SUBJECT: TRIP REPORT - ELECTRICAL CABLE ISSUES, WATTS BAR NUCLEAR
PLANT, UNIT 1 (TAC NO. 71917)

Subject: Special Assessment Report
Evaluation of Elements Involved in Bounding the Cable
Pullby Damage Issue at Watts Bar Nuclear Station

SPECIAL ASSESSMENT REPORT
EVALUATION OF WATTS BAR CABLE ISSUES
CABLE BEND RADIUS - VERTICAL DROP - CABLE JAMMING

SECTION A-A

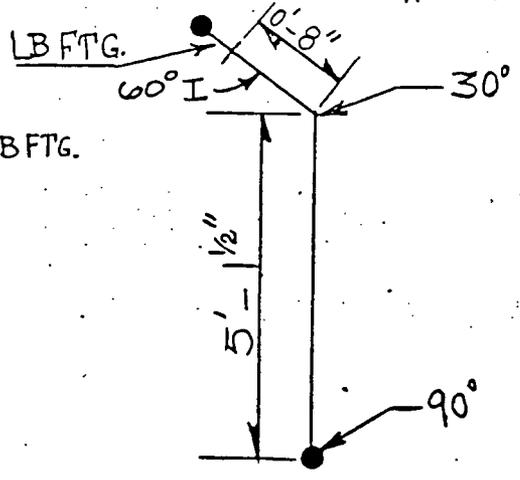
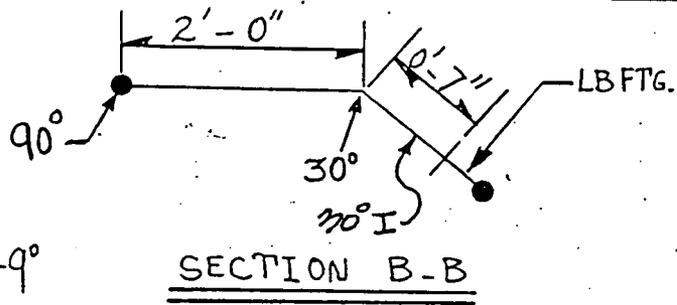
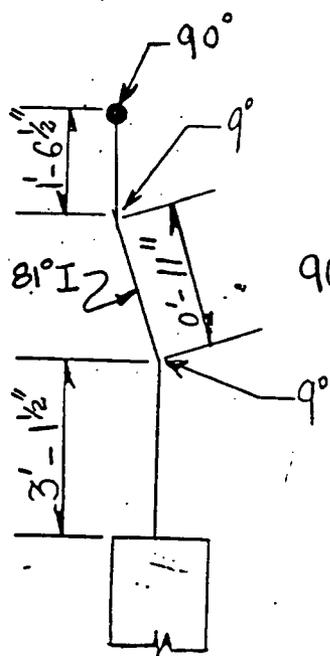
During the walkdown, inspectors identified several discrepancies between the isometric and the installed configuration of conduit 1PM6350G.

- Beginning at the intersection of junction box 1-JB-292-1200 approximately 45 feet of the conduit is physically labeled 1PM5560G instead of 1PM6350G as shown on the isometric.

- Sections (A-A) through (C-C) shown on page 60 of the isometric do not accurately reflect the installed configuration of the subject conduit. The physical configuration exhibits a junction box, LB fitting, and 90 degree bend which are not shown on the isometric.

In response to these observations, TVA engineering personnel provided the inspectors a copy of Design Change Notice (DCN) 10469-A. This document specified the rework of the subject conduit to resolve a violation of separation criteria between the conduit and hot pipe. The inspectors noted that the design change does reflect the physical configuration observed in the field as well as the change in conduit labeling. Additionally, the review of associated work packages indicates that conduit rework had not been accomplished at the time of the TVA cable damage isometric walkdown. Consequently, the inspectors believe that the isometric in question did accurately reflect field conditions when initiated. No additional discrepancies were noted.
